**King's Mark
Environmental
Review
Team
Report**

**Northwest Development
Condominiums
Litchfield,
Connecticut**

Environmental Review Team Report

JANUARY 1988

**PROPOSED
SITE PLAN**

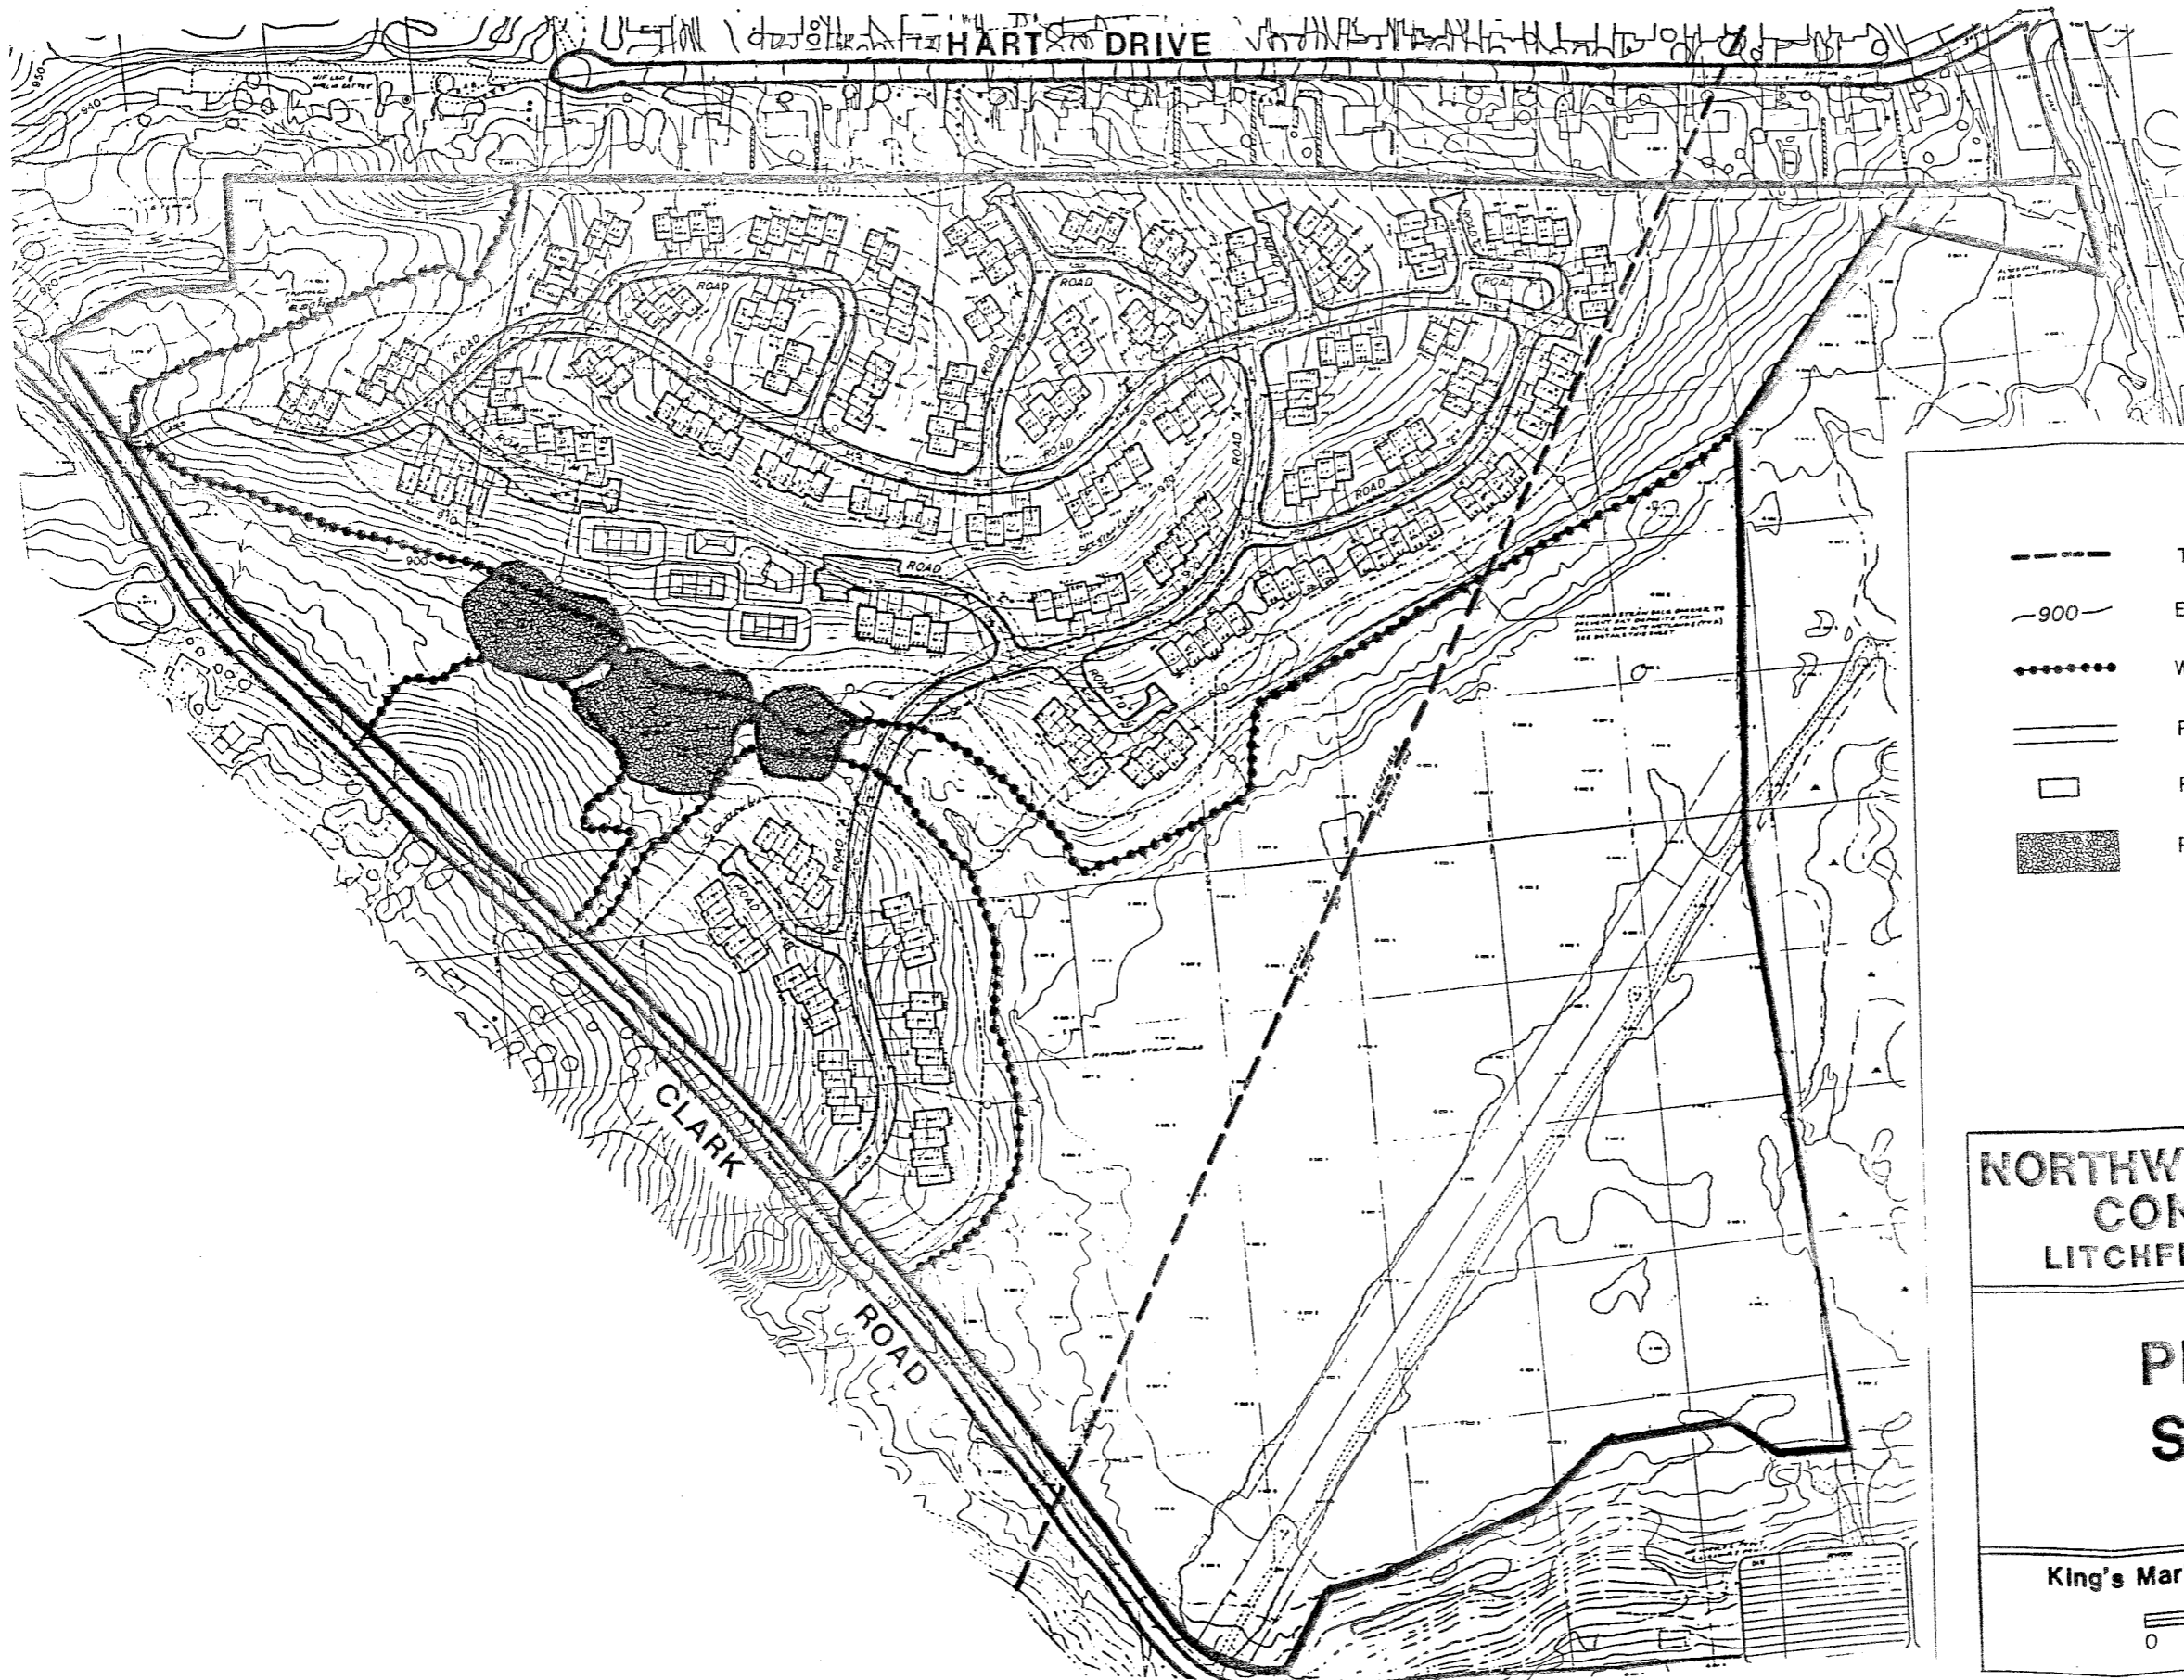
Based on the site plans, it appears that a number of units and cul-de-sacs may infringe on the 60-foot rear lot setback. This should be checked on the plans and during construction so that the potential impacts from the development will be minimized.

Sightline distances on Clark Road and Roads A and I might be reconsidered to provide sightline distances of 600 feet in each direction. Traffic is fast moving in this area. Distances could be achieved by clearing vegetation and some regrading of the slopes along the side of the road.

According to present plans, the project will require the traverse of two regulated areas: (1) an approximately 30 foot crossing at the intersection of Clark Road and Road "I" and (2) an approximately 40 foot crossing on Road "A" in the central parts.

Based on the site plans available the day of the field review, it appears that a number of proposed units on the western border of the site may infringe on the 60 foot rear lot line setback required by the Litchfield Zoning Regulations. This should be carefully checked both on the final site plans and in the field during construction. To comply with the spirit of the buffer zone concept, consideration should also be given to relocating any cul-de-sacs which would intrude into this buffer zone. As stated above, particular care is needed along this border of the site to ensure that the project is appropriately screened with a vegetative buffer to minimize potential impacts to the established neighborhood on Hart Drive.

Sightlines on Clark Road and Roads A and I might be reconsidered to provide for a sightline distance of approximately 600 feet in each direction. This could be achieved by clearing vegetation with some regrading of the existing slopes on Clark Road. Roads A and I intersect Clark Road with a positive grade to the south. Current traffic is fast moving for this class of road. Since Clark Road connects to Route 118 and 202, the intersections of Road A and I should provide for increased traffic.

Road J - the proposed configuration ending in a "hammerhead" should be reviewed to determine if a loop from Road I to Road K and back through to Road I could be developed.

Road I - the westerly portion should be reviewed to determine if a southeasterly shift might be made to improve site lines for a number of intersecting roads.

Roads A, C and D - there is the potential to shift and match Roads D and C to a common intersection at Road A.
